ORIGINATION FORM

Proposed Revisions to a Standard Plans Index
(Please provide all information — Incomplete forms will be returned)

Index Number: 700-120

Index Title: Enhanced Highway Signing Assemblies

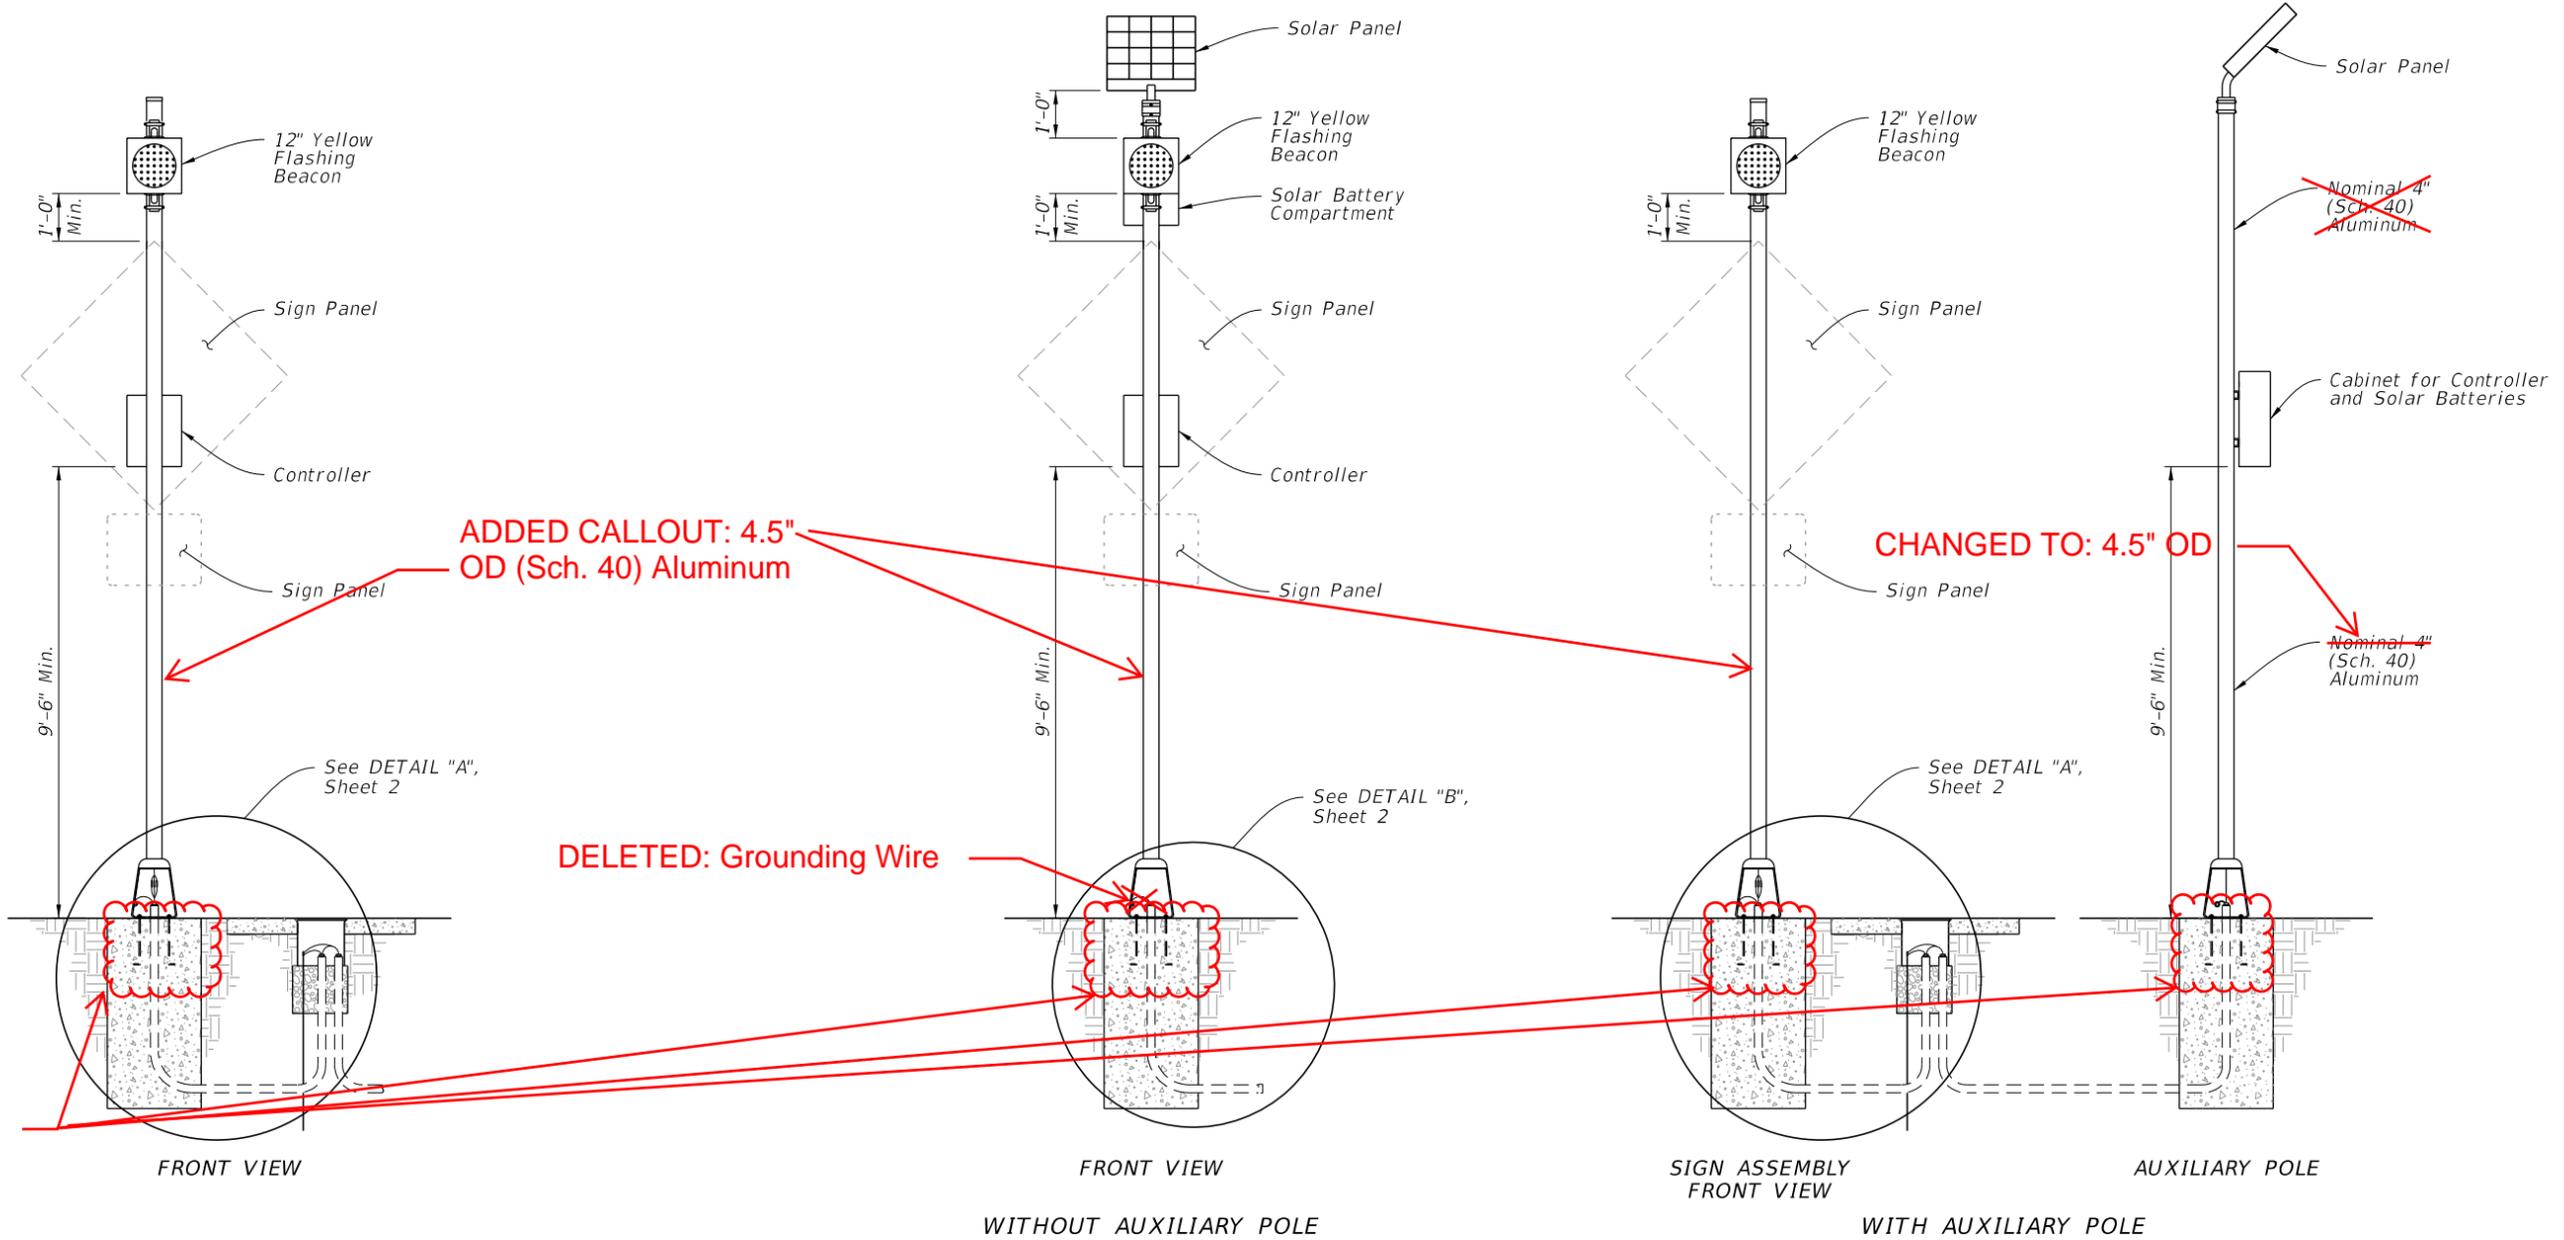
Sheet 1: Deleted the ground wire from the FRONT VIEW in the POWER CONFIGURATON 'B' - WITHOUT AUXILIARY POLE.

Sheet 1: Updated General Note 4; Change all references "4" Nominal Aluminum Pole" to "4.5" OD Aluminum Pole; Updated anchor bolts.

UPDATED: Anchor Bolts

ADDED CALLOUT: 4.5" OD (Sch. 40) Aluminum

CHANGED TO: 4.5" OD

CONDUIT, WIRING, AND FOUNDATION DETAILS

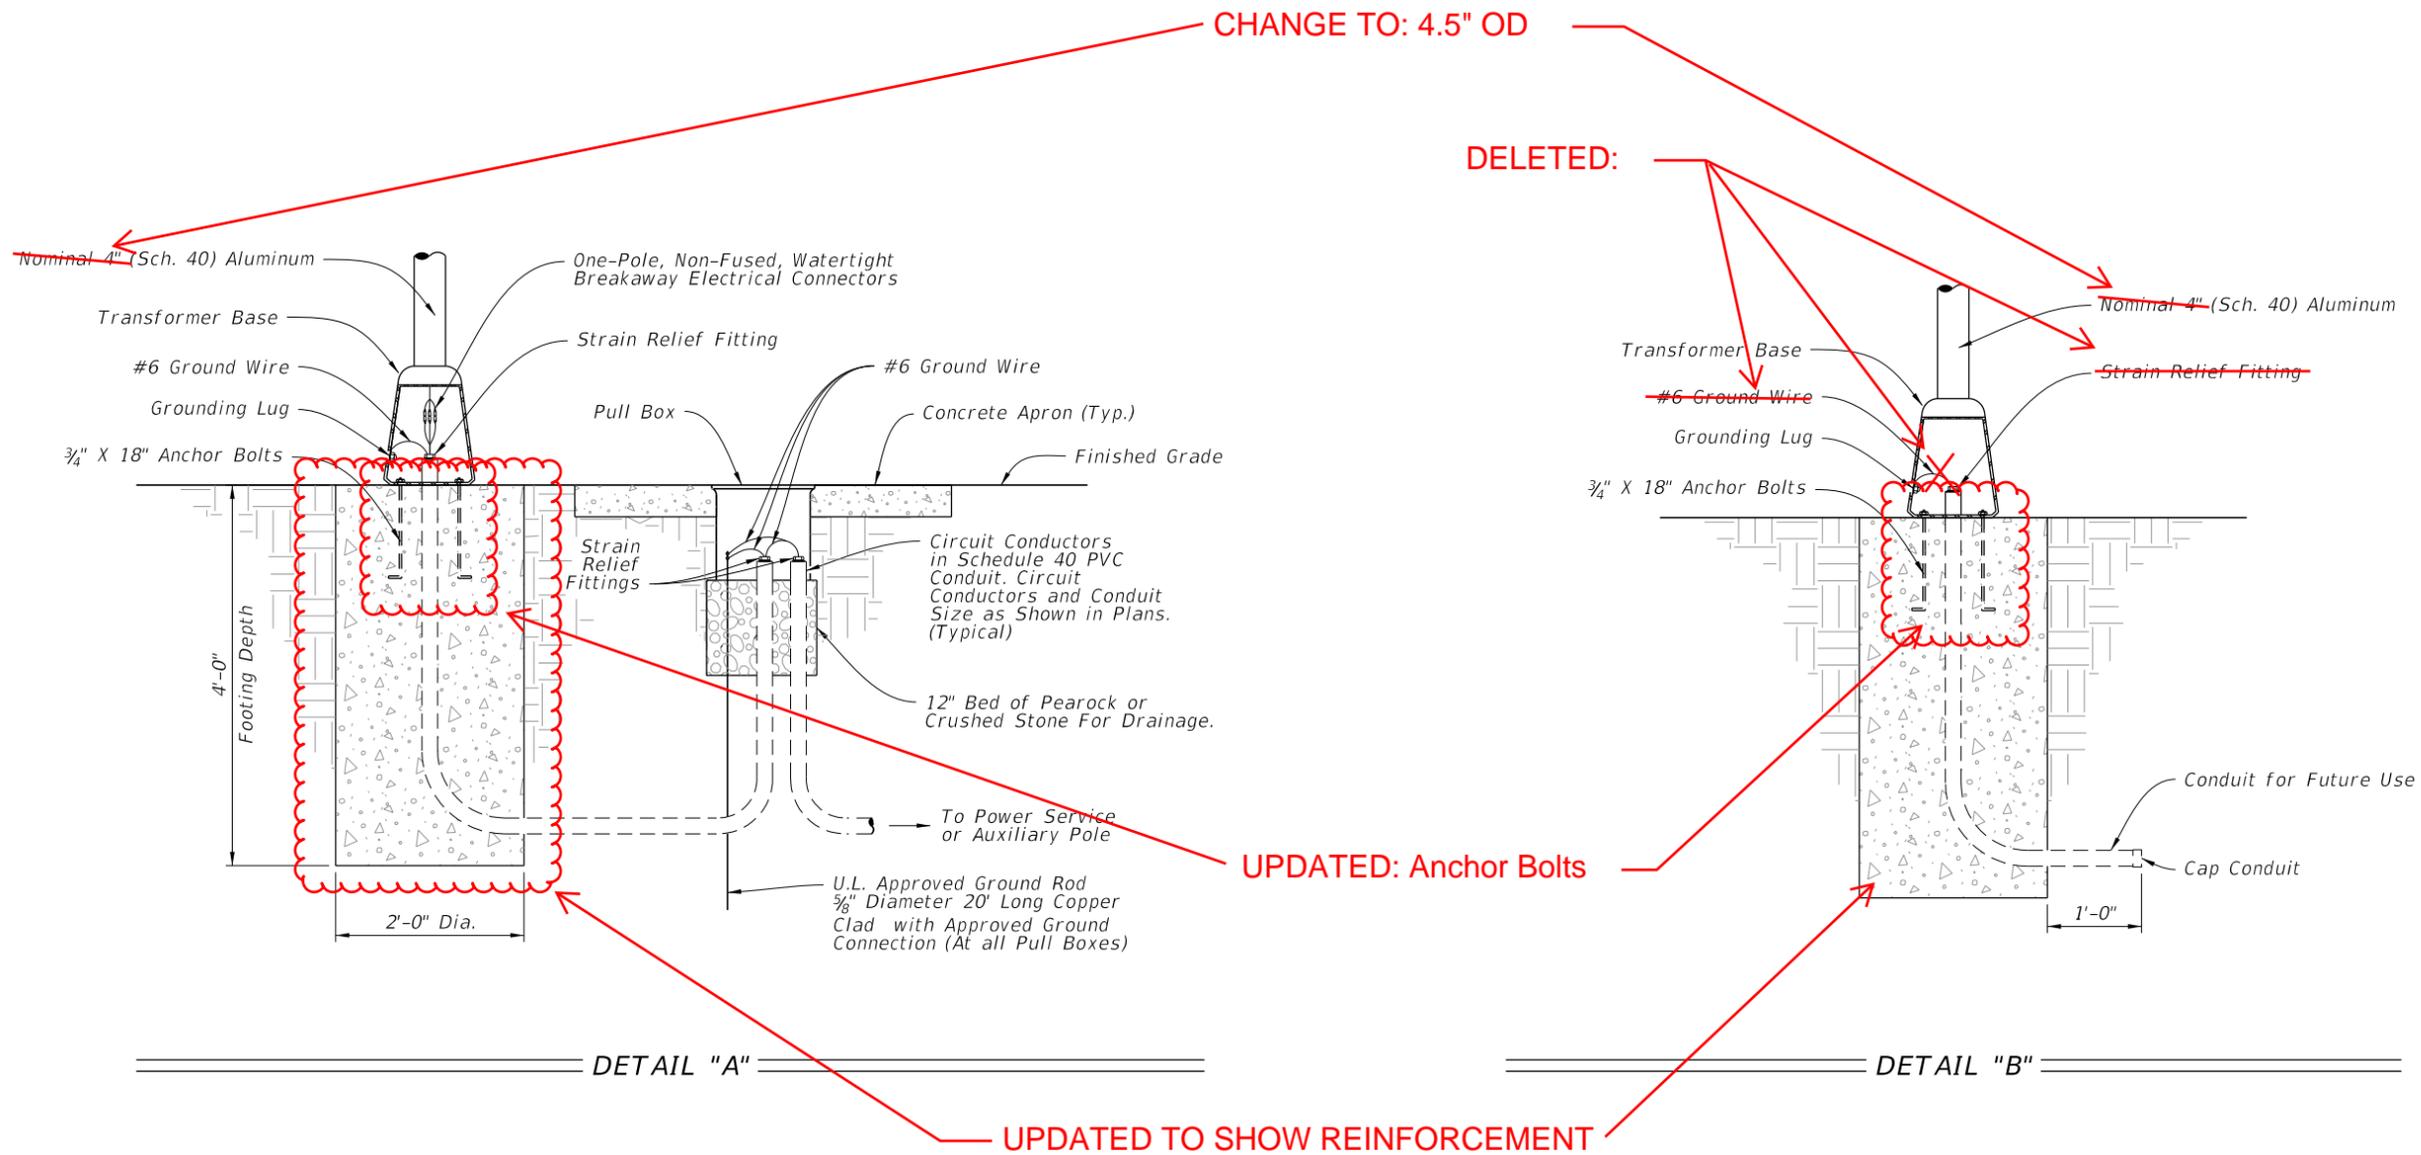
Sheet 2: Deleted the ground wire and strain relief fitting from DETAIL "B".

Sheet 2 - A ground wire is not required for a sign assembly without an auxiliary pole. The ground wire will be removed from Detail B on Sheet 2.

Sheet 2: Add new detail to show foundation reinforcement; Change all references "4" Nominal Aluminum Pole" to "4.5" OD Aluminum Pole; Updated anchor bolts.

DELETED: Grounding Wire

~~Nominal 4" (Sch. 40) Aluminum~~

ROADSIDE SIGN ASSEMBLY-1

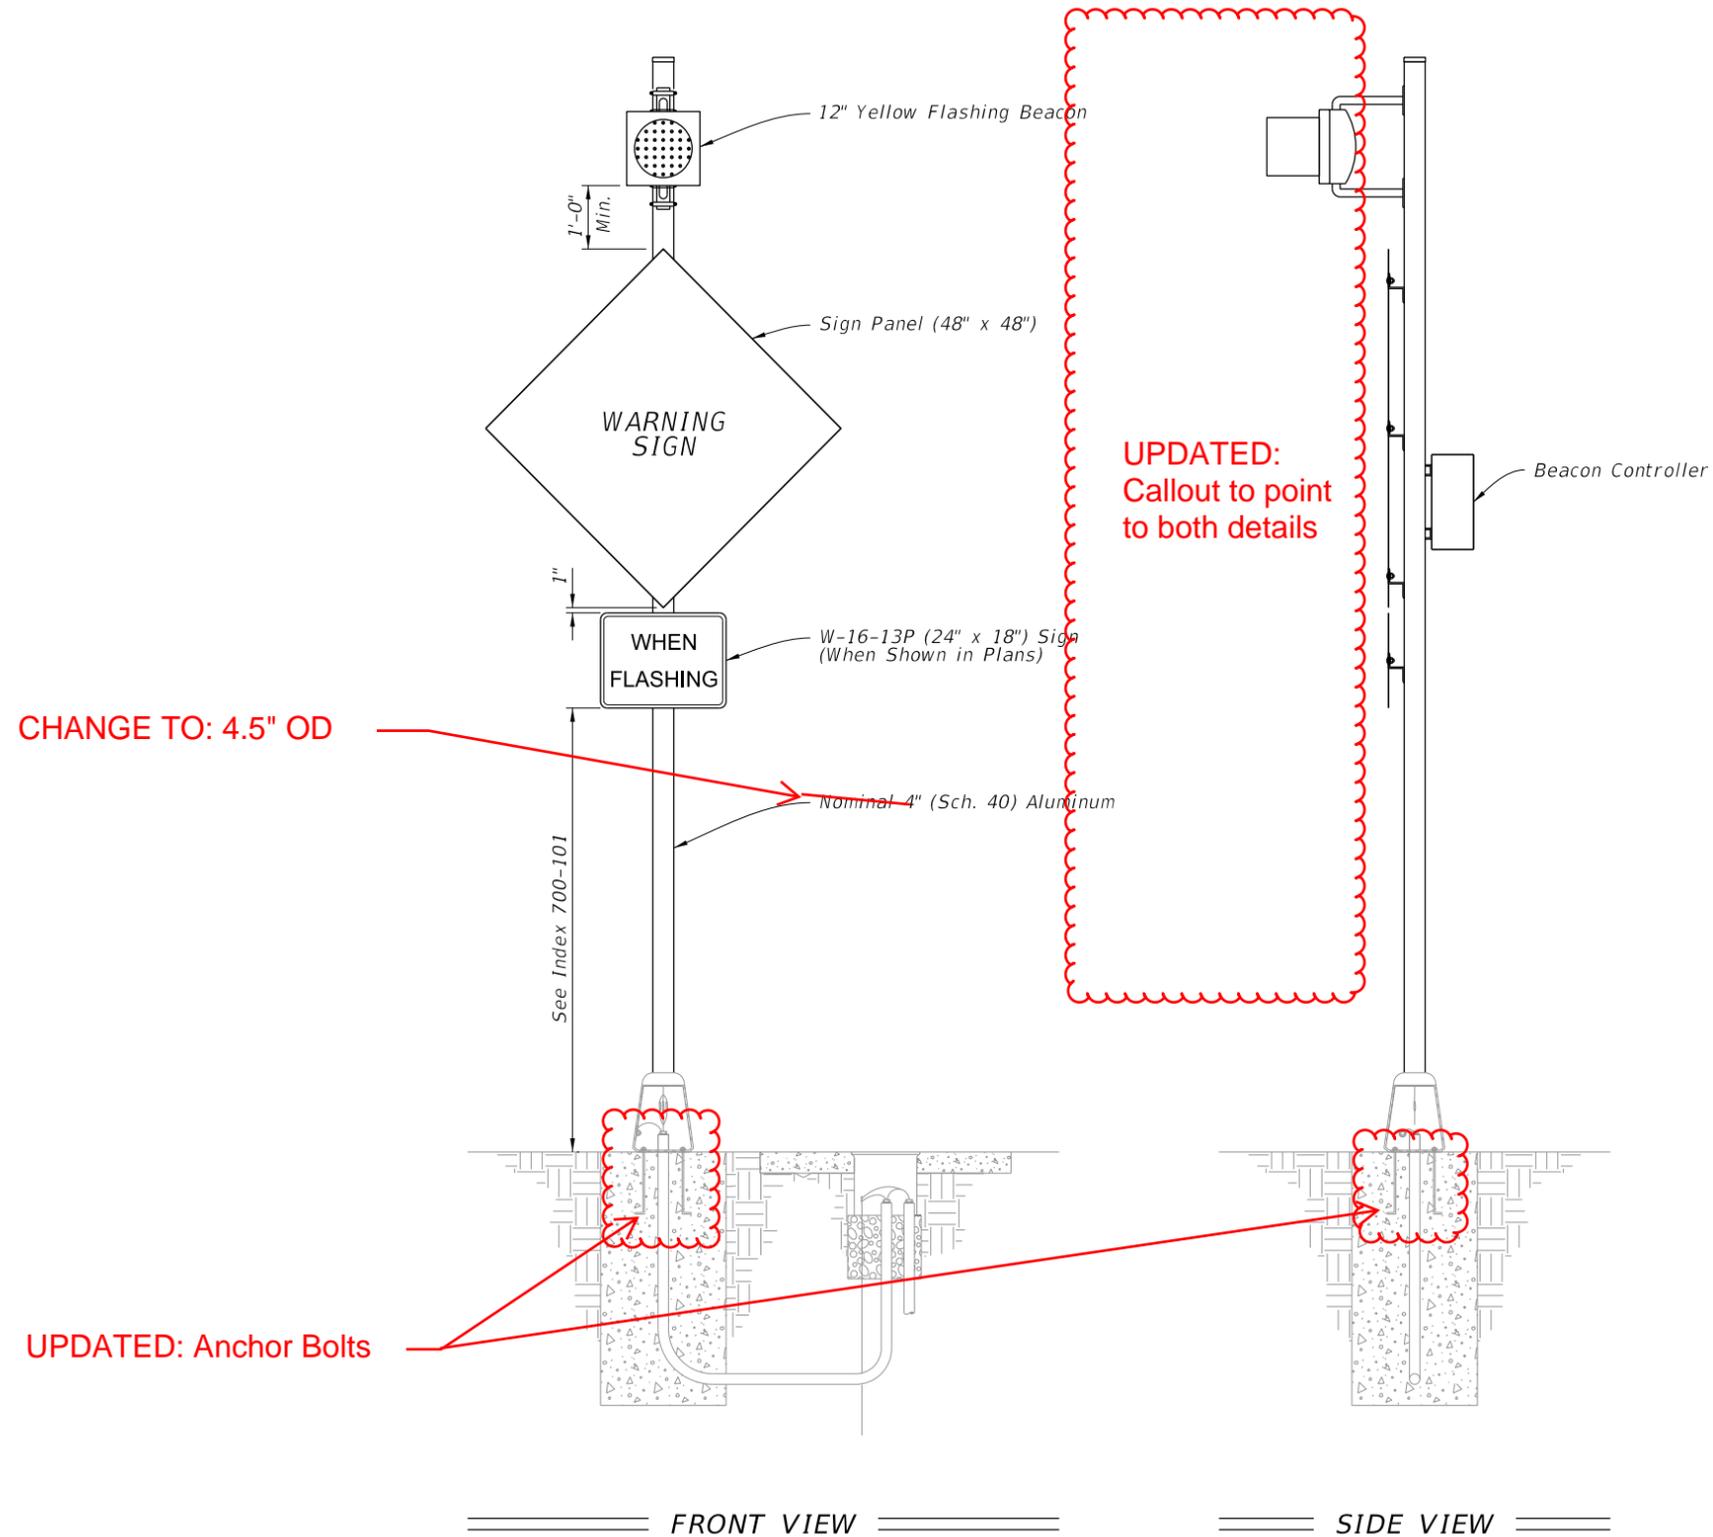
Sheets 3 through 11: Updated callouts to point to both details; Change all references "4" Nominal Aluminum Pole" to "4.5" OD Aluminum Pole; Updated anchor bolts; Added Note "Foundation reinforcement not shown".

ADDED NOTE:
 Foundation reinforcement not shown.

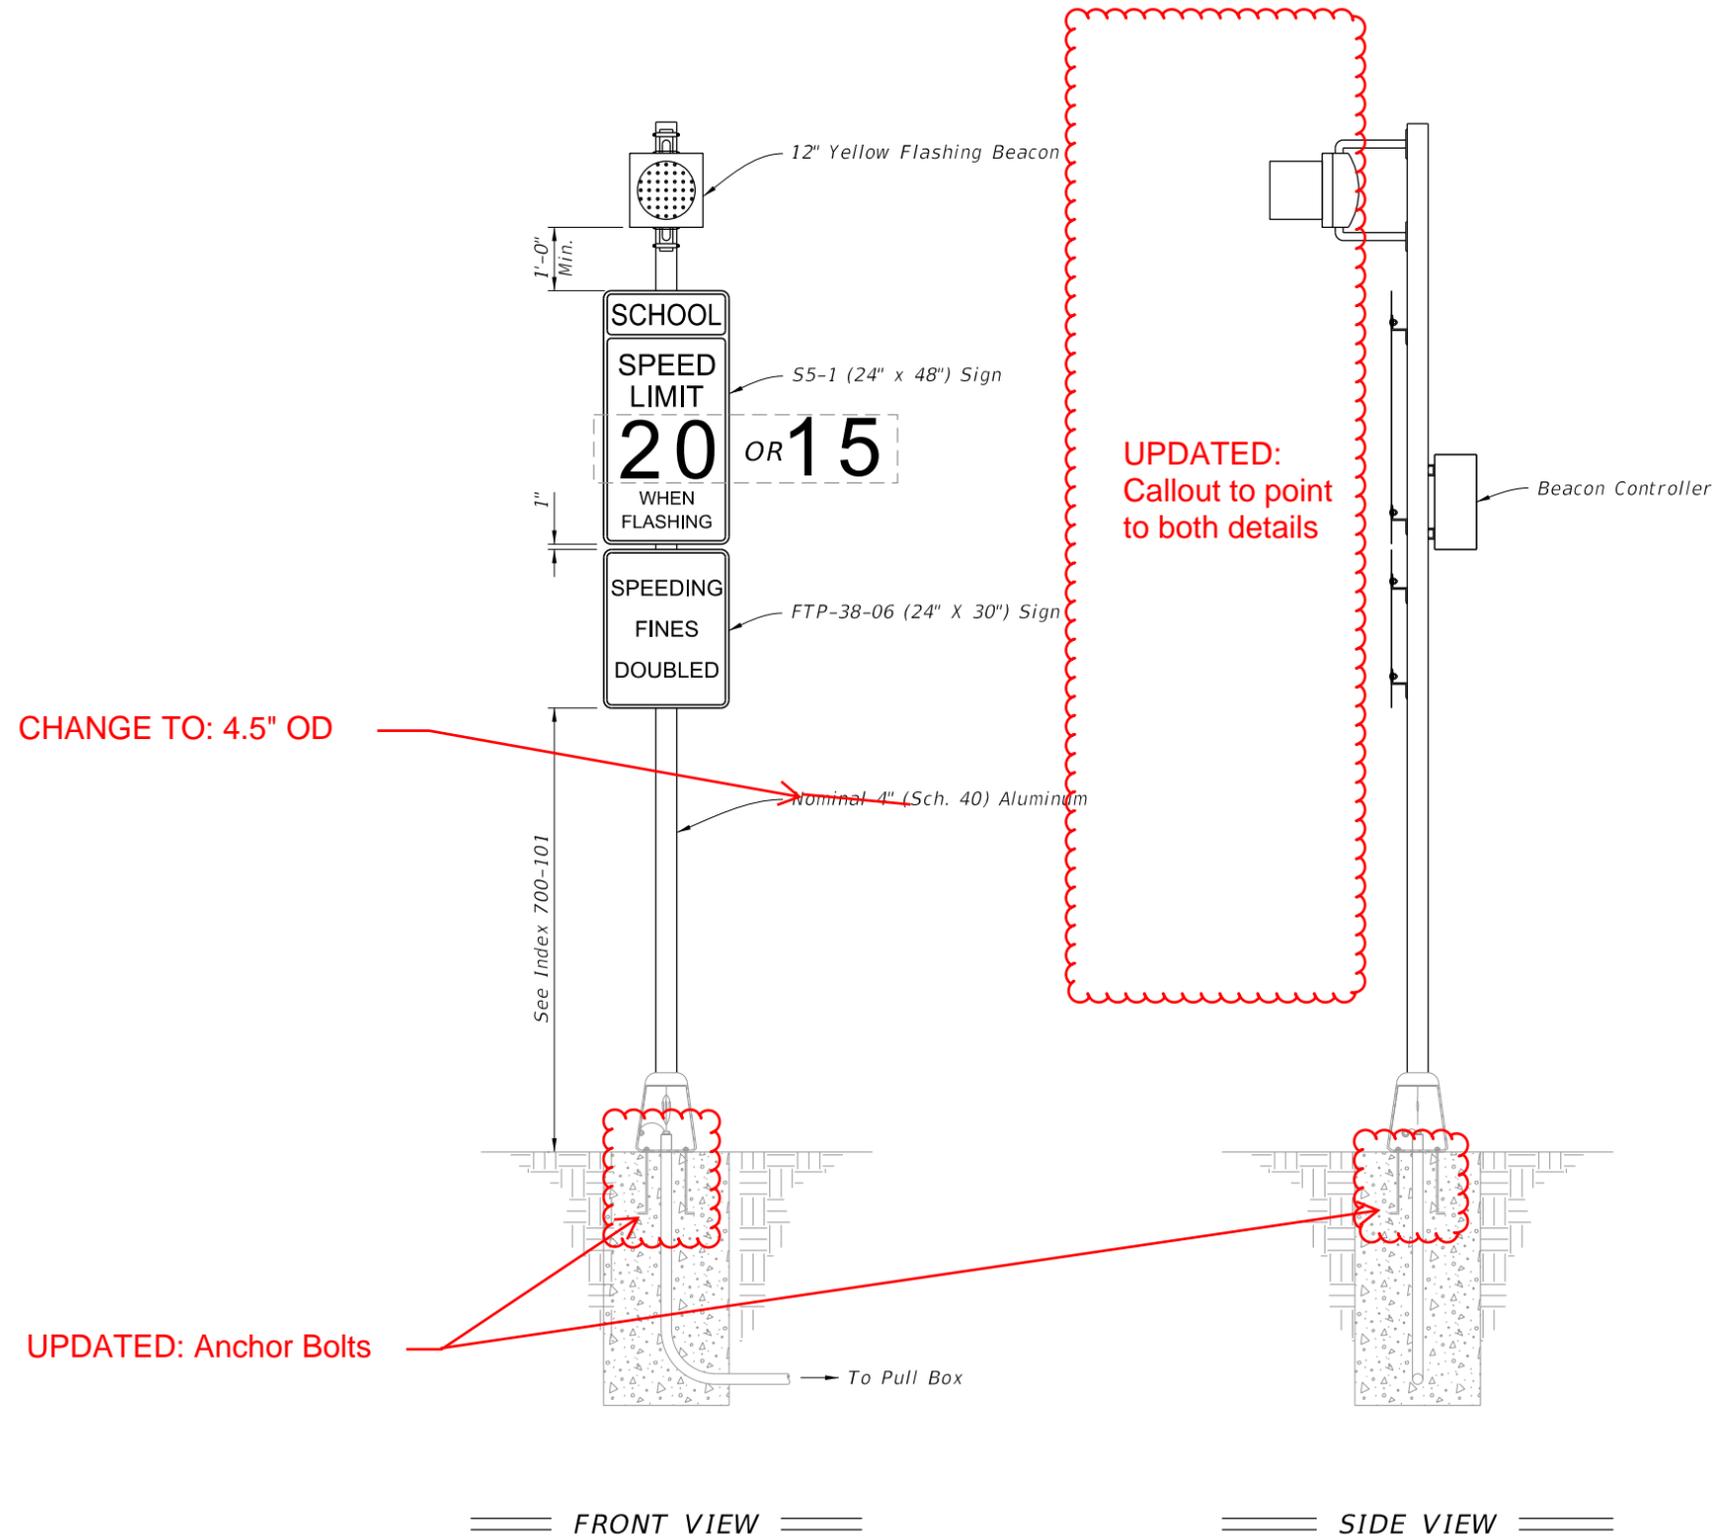
ADDED NOTE:
 Foundation reinforcement not shown.
